UNITED STATES
NUCLEAR REGULATORY COMMISSION
WASHINGTON, D. C. 20555

SUBJECT: ISSUANCE OF AMENDMENT NOS. 99 AND 73 TO FACILITY OPERATING
LICENSE NOS. DPR-51 AND NPF-6 FOR ARKANSAS NUCLEAR ONE,
UNIT NOS. 1 AND 2 (ANO-1 & 2)

Amendment No. 99
License No. DPR-51

Amendment No. 73
License No. NPF-6

FIGURE 6.2-1 MANAGEMENT ORGANIZATION CHART

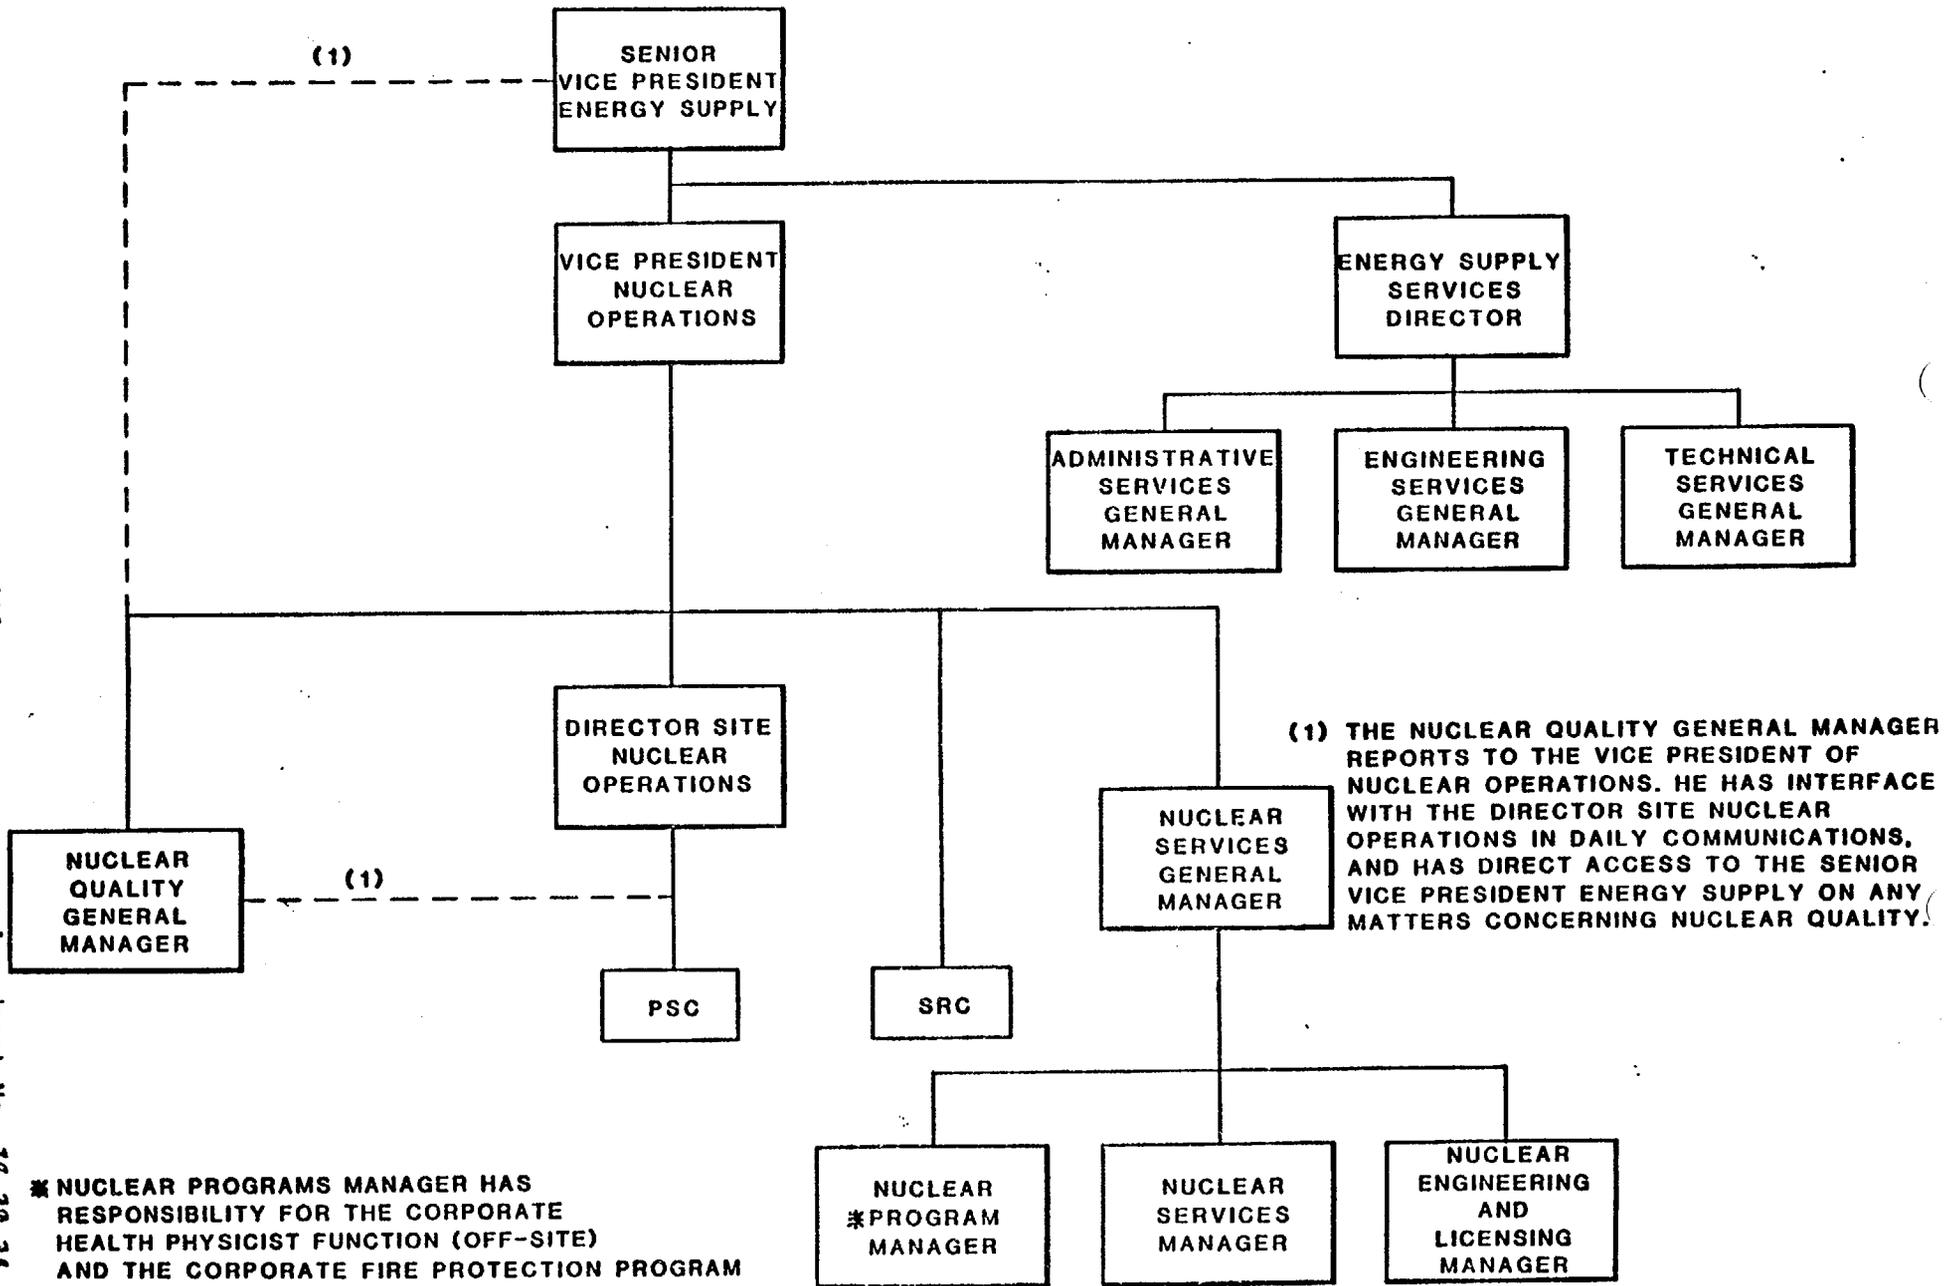
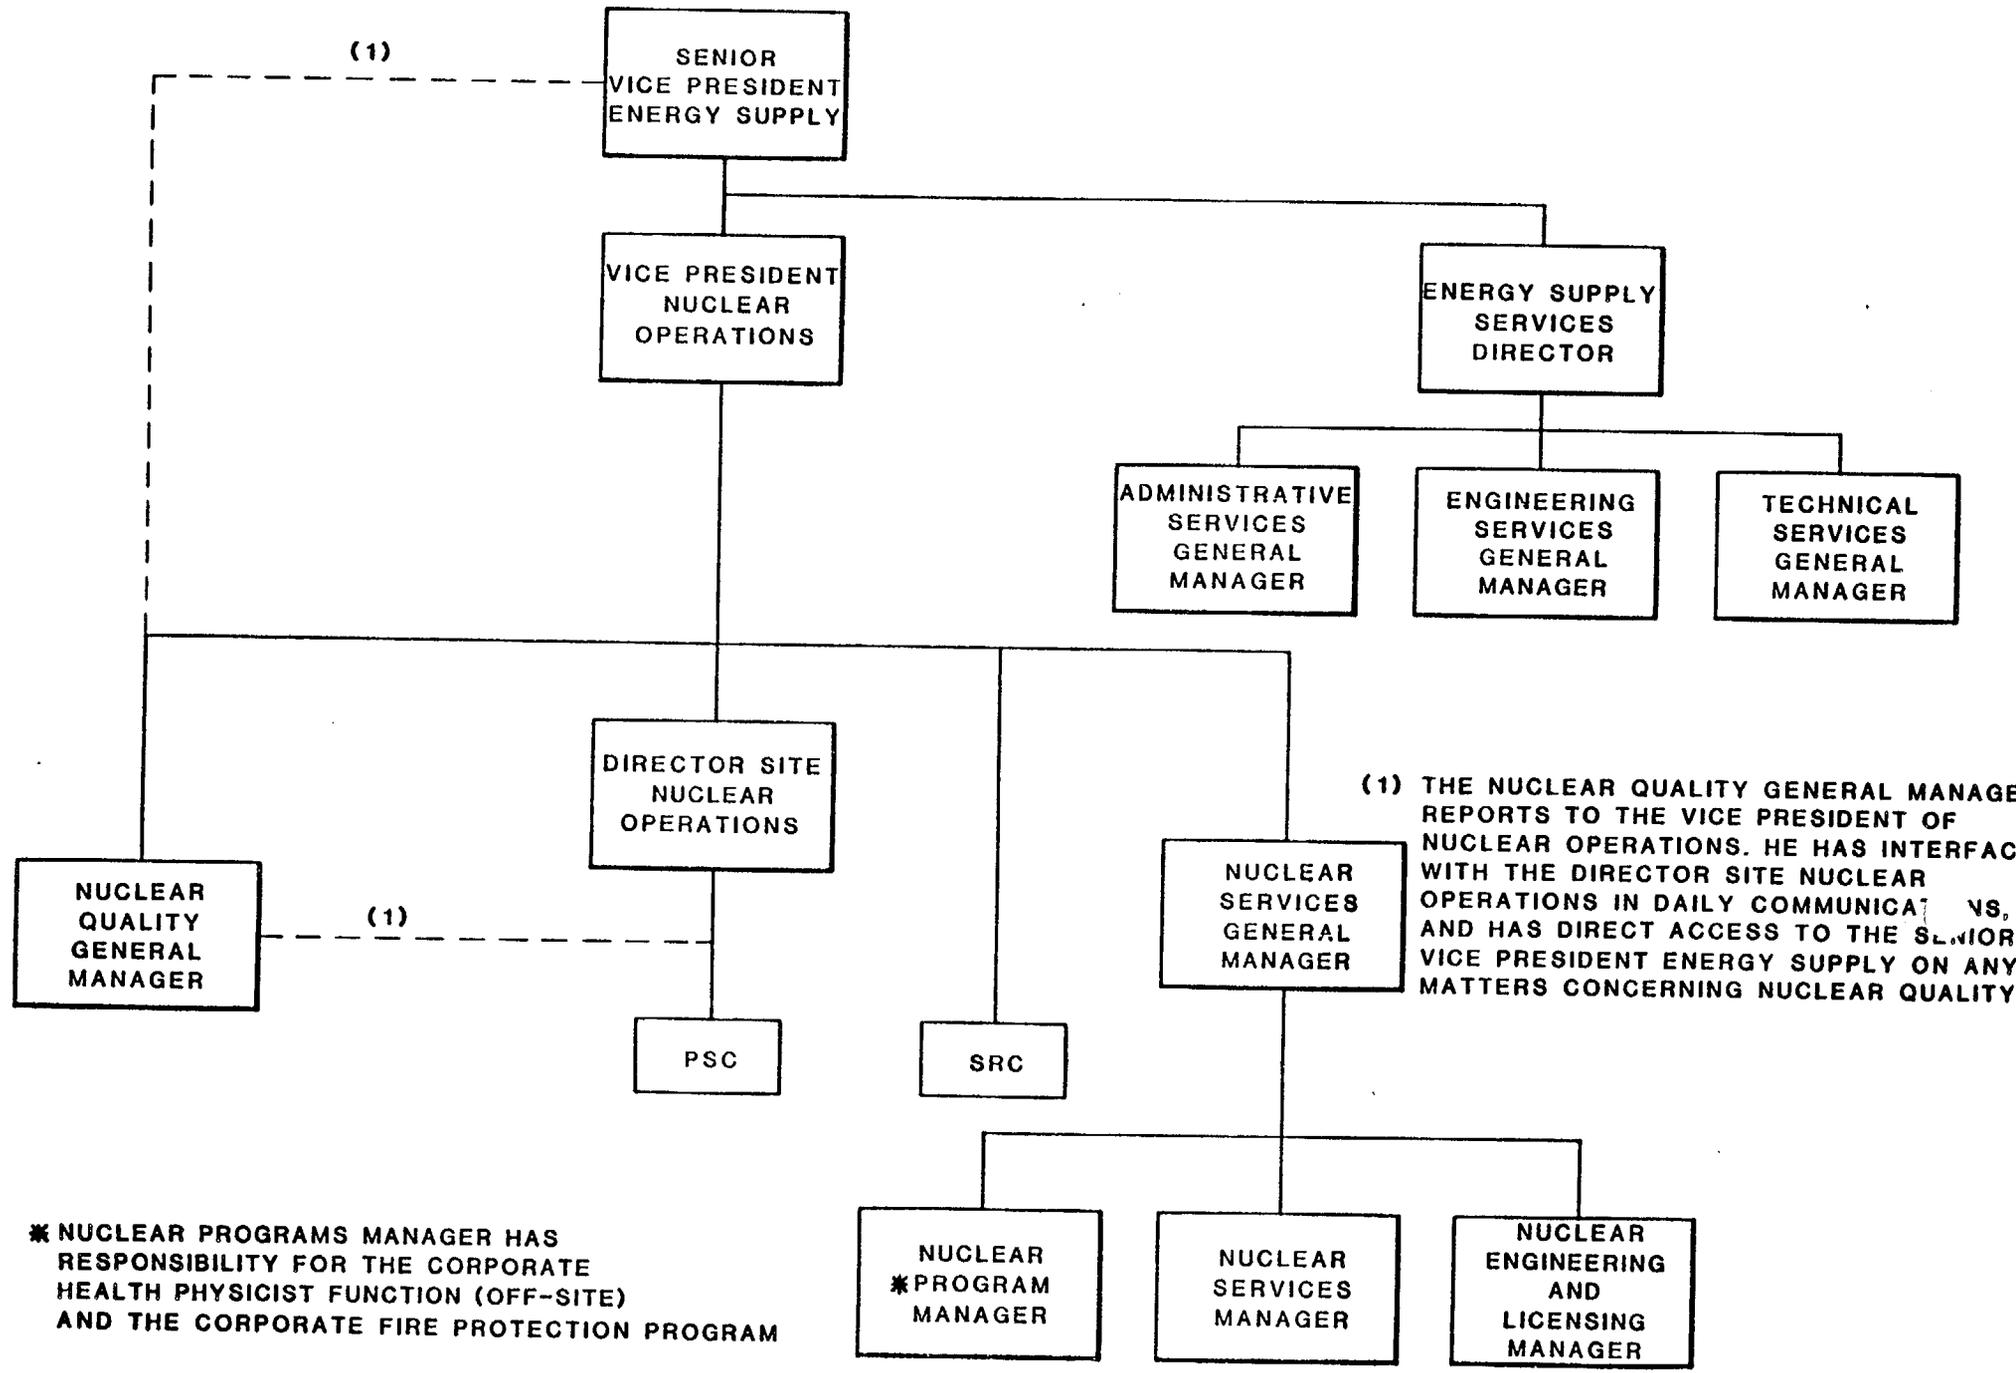
1. Figure 6.2-1 - Management Organization Chart

AP&L has revised the organization under the Vice President, Nuclear Operations. These changes include the following:

FIGURE 6.2-2 FUNCTIONAL ORGANIZATION FOR PLANT OPERATIONS

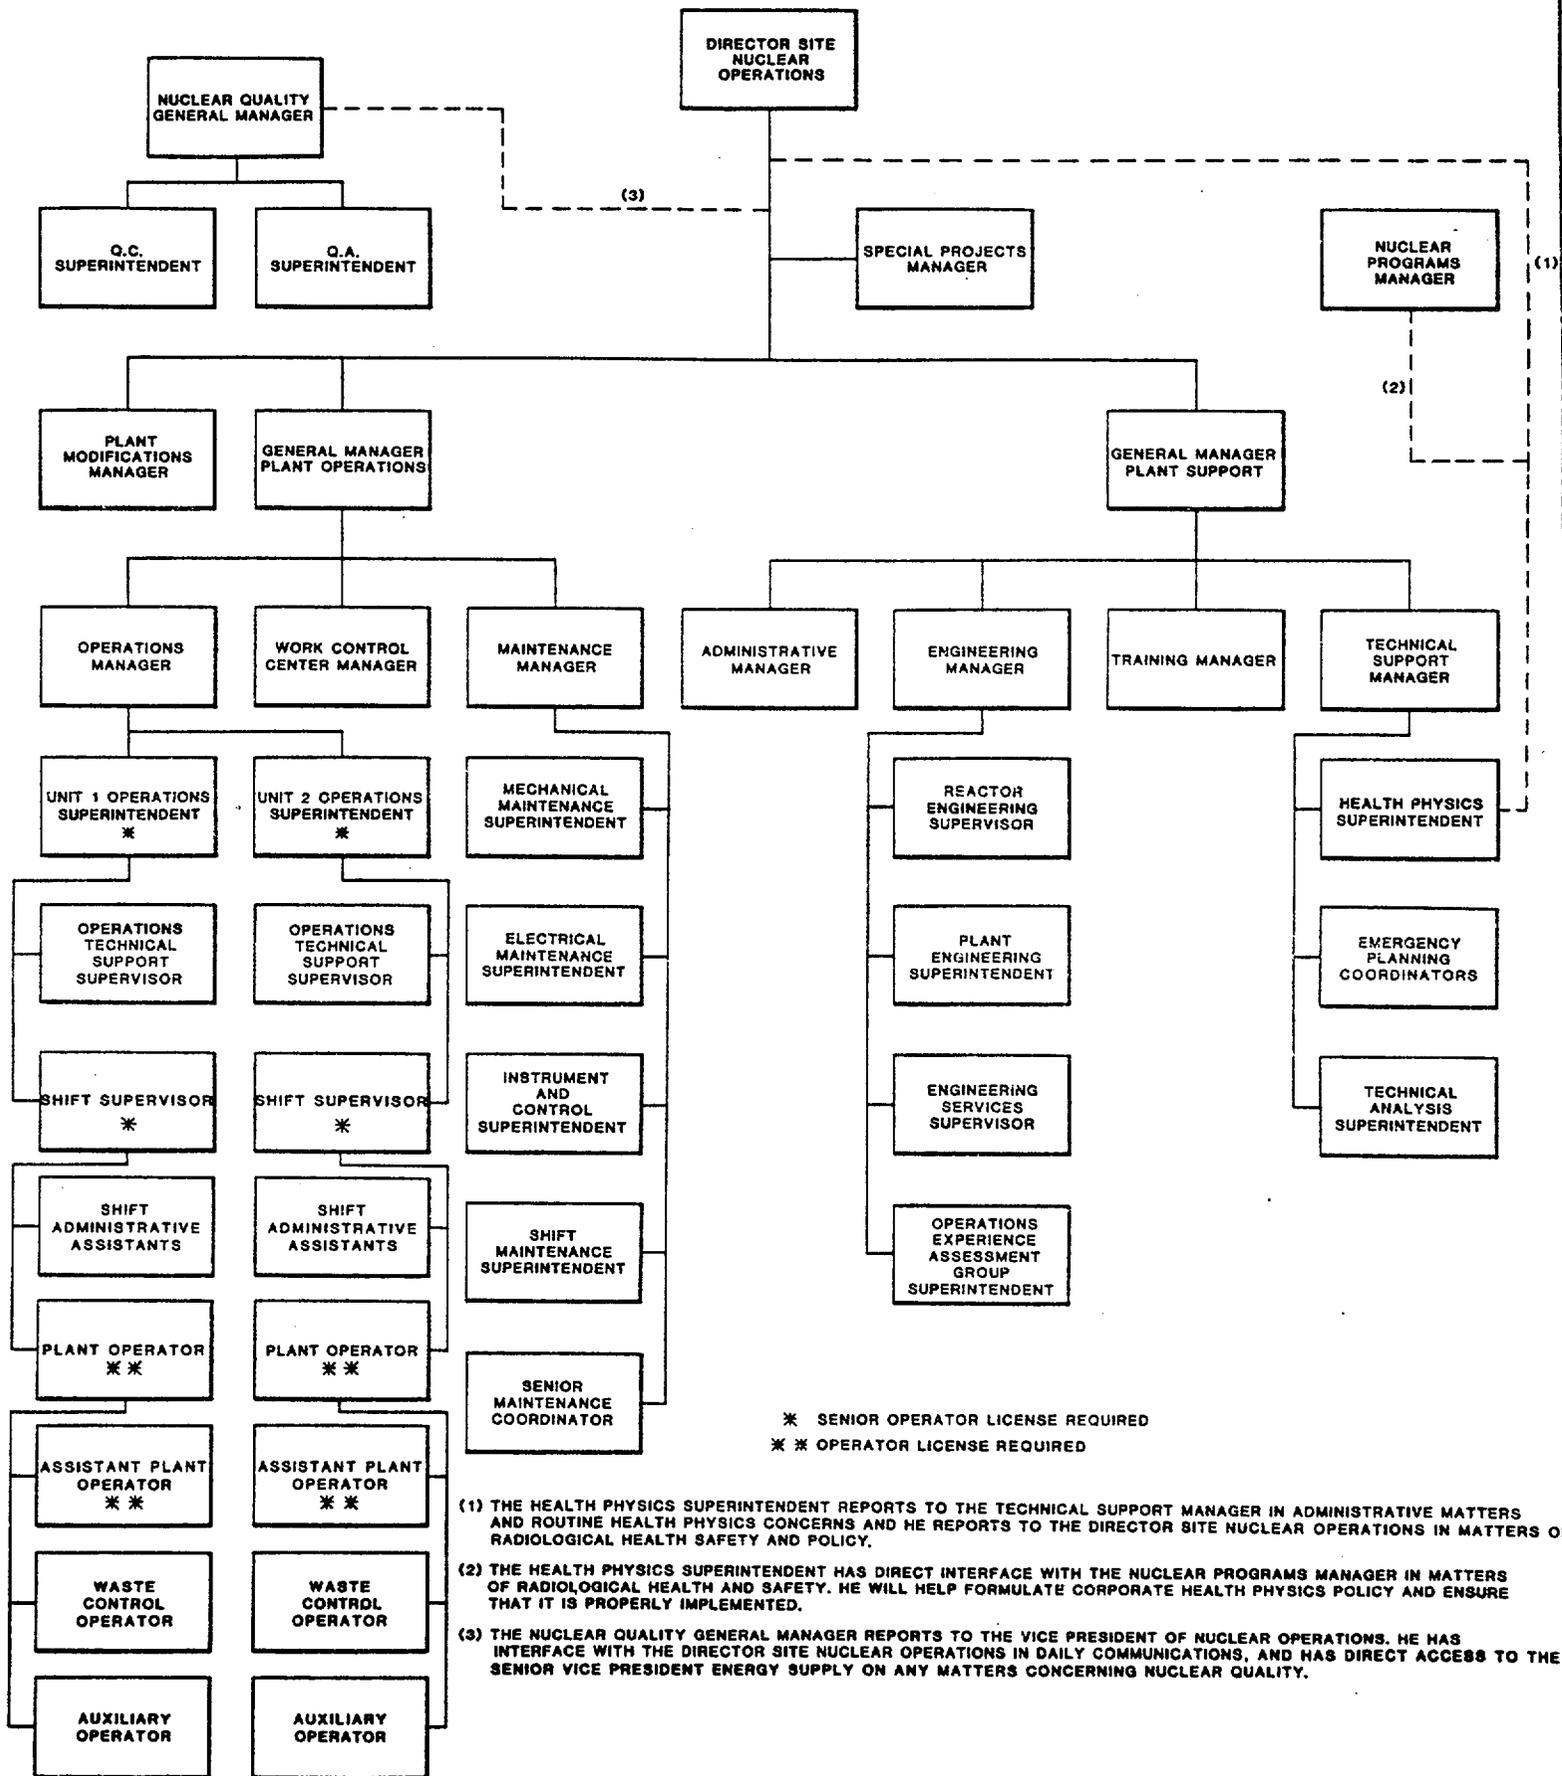
2. Figure 6.2-2 - Functional Organization for Plant Operations

AP&L has revised the site organization for Arkansas Nuclear One (ANO). The changes include the following:

- a. The new position of Director, Site Nuclear Operations who has overall responsibility for the site has been established. Reporting to the Director, Site Nuclear Operations will be the new positions of Plant Modifications Manager who is responsible for all ANO construction projects, the General Manager Plant Operations who is responsible for the operation and maintenance of ANO, the new position of General Manager Plant Support who is responsible for Engineering, Training and Technical Support, and the Special Projects Manager.

The staff has reviewed these changes and determined that they will enhance the effectiveness of the Director, Site Nuclear Operations in that by delegating some of his responsibilities to the General Manager Plant Operations and the General Manager Plant Support, his attention can be focused on activities related to important safety issues. In addition, the proposed site organization still maintains clear lines of authority to the Director, Site Nuclear Operations and responsibility for all activities important to the safe operation of the facilities. Therefore, these changes meet the applicable acceptance criteria of Section 13.1.2, "OPERATING ORGANIZATION", and are acceptable to the staff.
